Neighborhood Meeting Report

148 Morrison Ave, Somerville

Location: Virtual/Zoom
Date: 9/8/25
Time: 6:30pm

LANDSCAPE PLAN
148 MORRISON AVE,
SOMERVILLE, MASSACHUSETTS
PARCEL ID:24_L_1

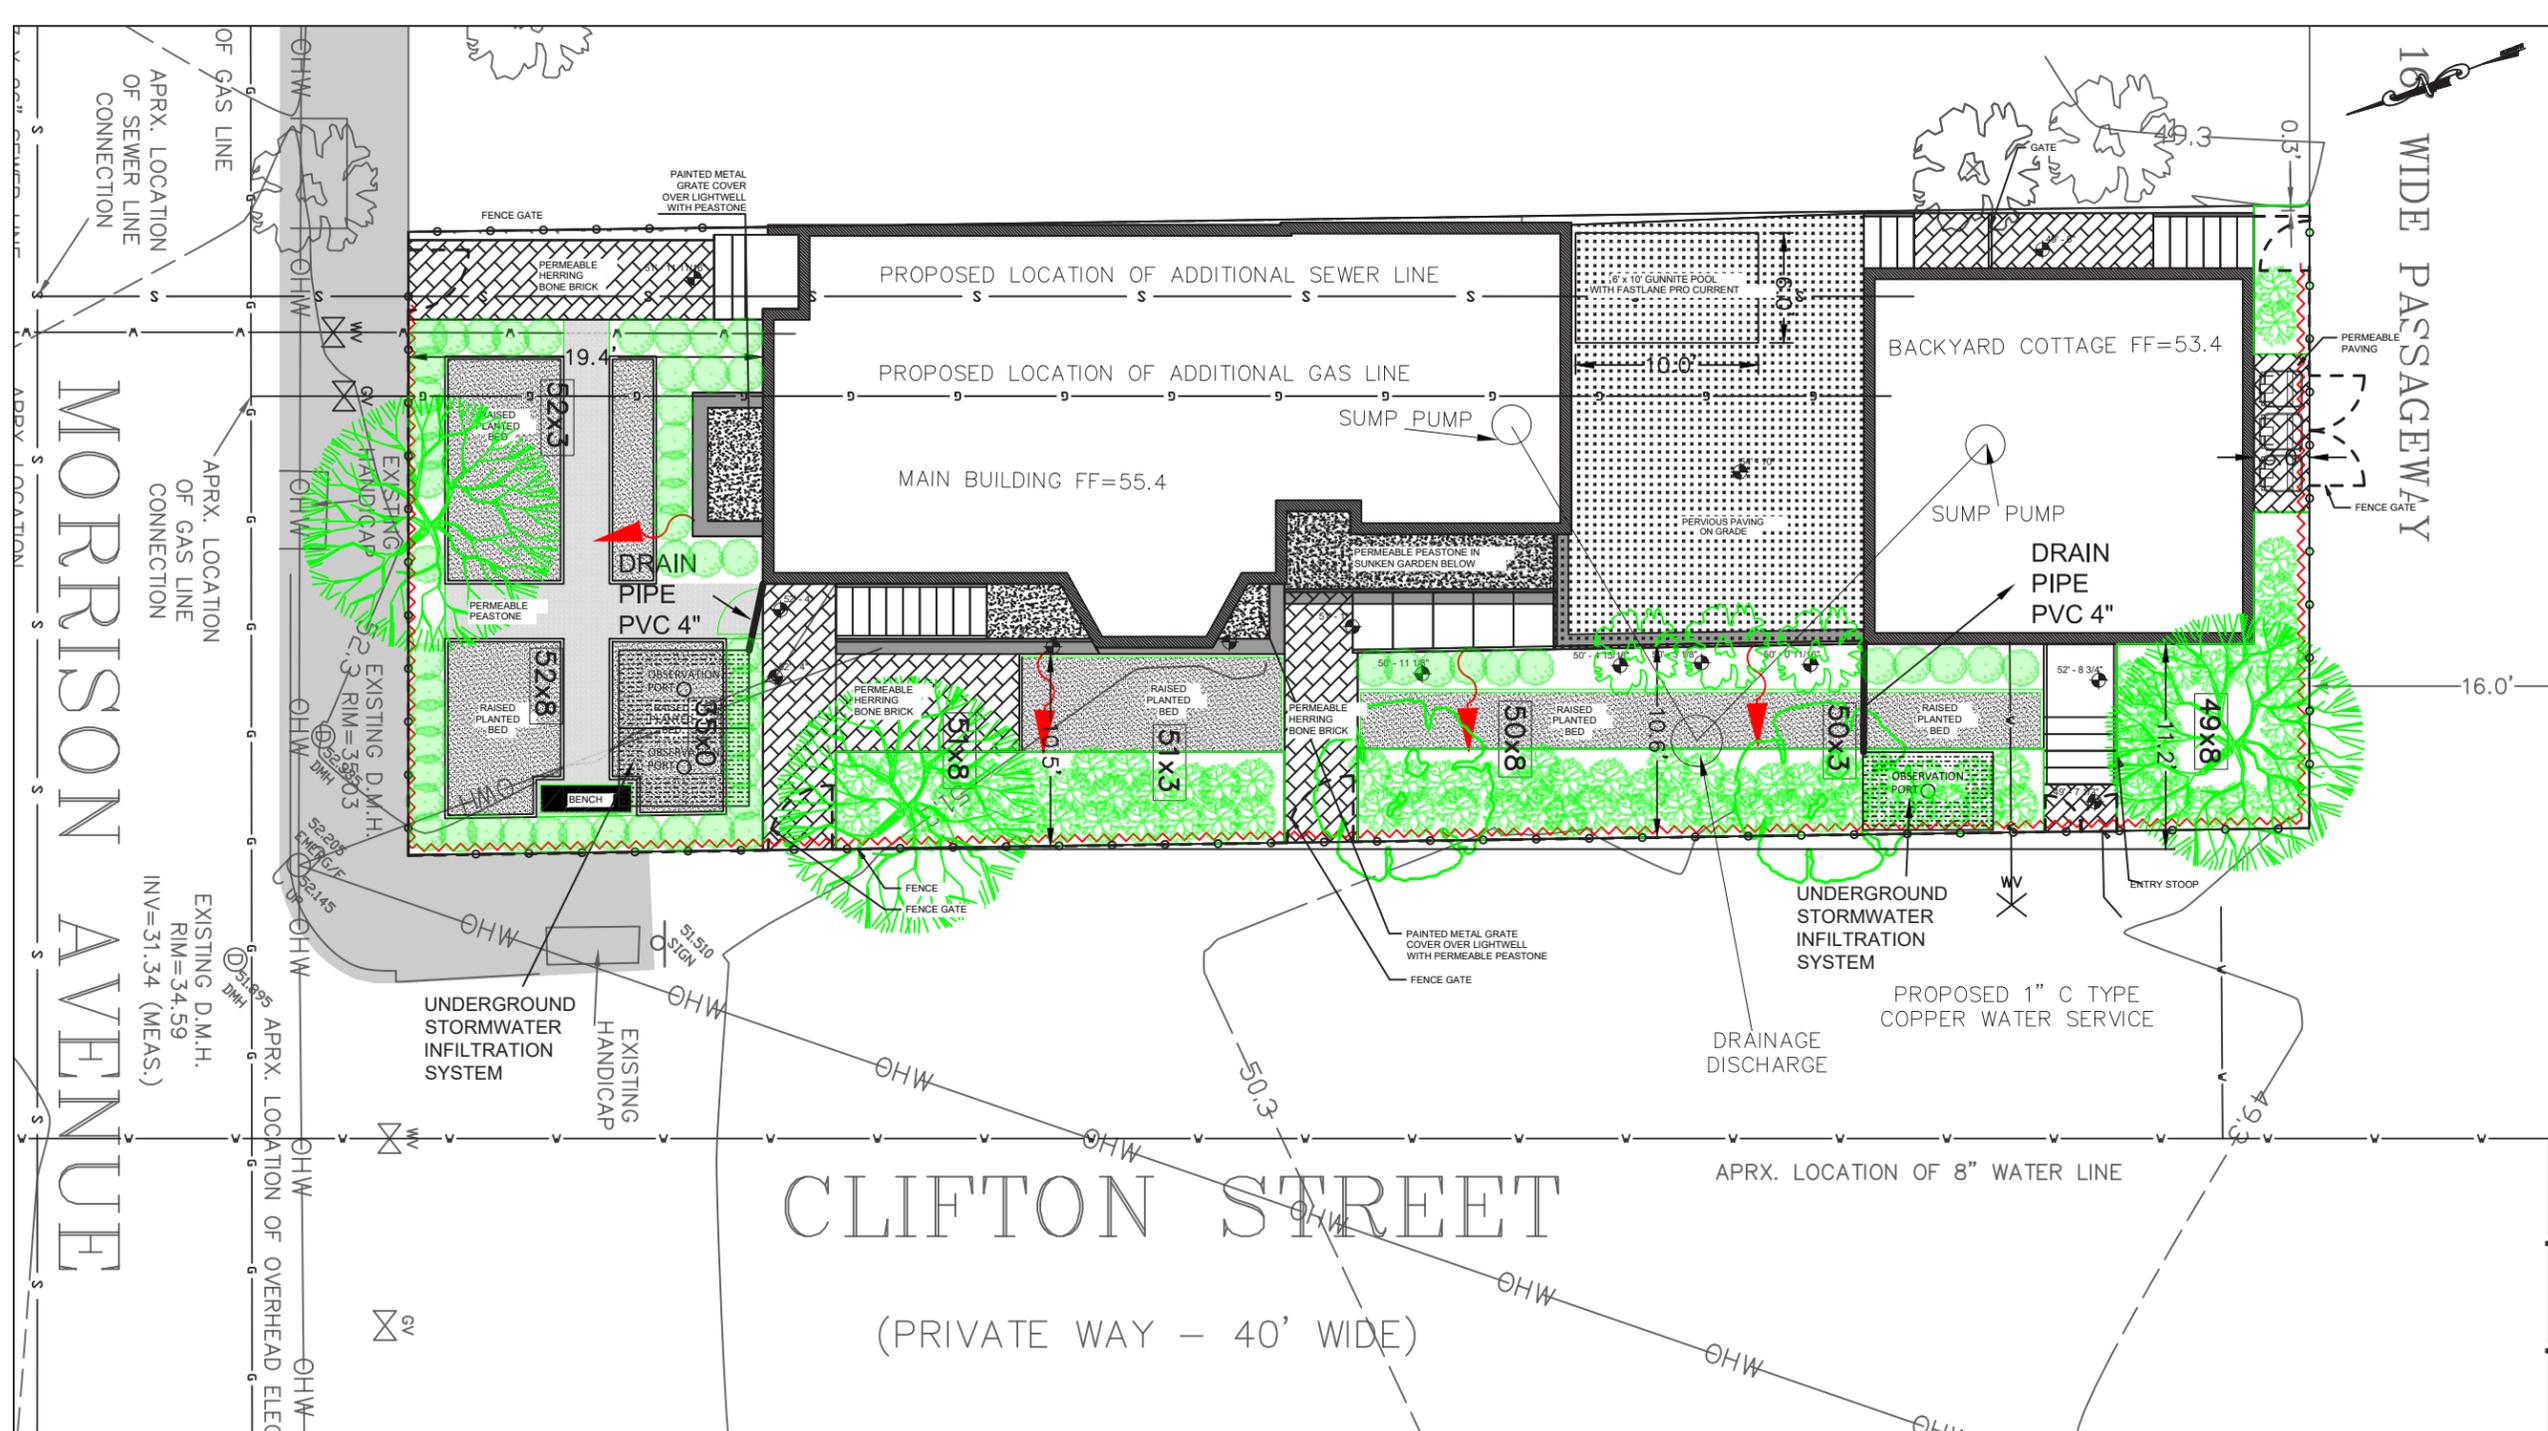
- Ms. Arnaud further raised concerns about the potential impact of lowering the basement level on neighborhood groundwater, citing flooding issues in a nearby property where similar work had been done. The property owners explained that a civil engineer has been engaged on the project and that the plans include an underground stormwater infiltration system.

- **Eilish Brown** asked whether the patio between the main building and the cottage would be permeable. The property owners confirmed that it would. Ms. Brown also suggested incorporating more native shrubs. The architect noted that the city maintains strict requirements regarding plant selection but reviewed the landscape plan in more detail and confirmed that additional native plantings are included. The property owners also confirmed that the existing flagpole will remain.
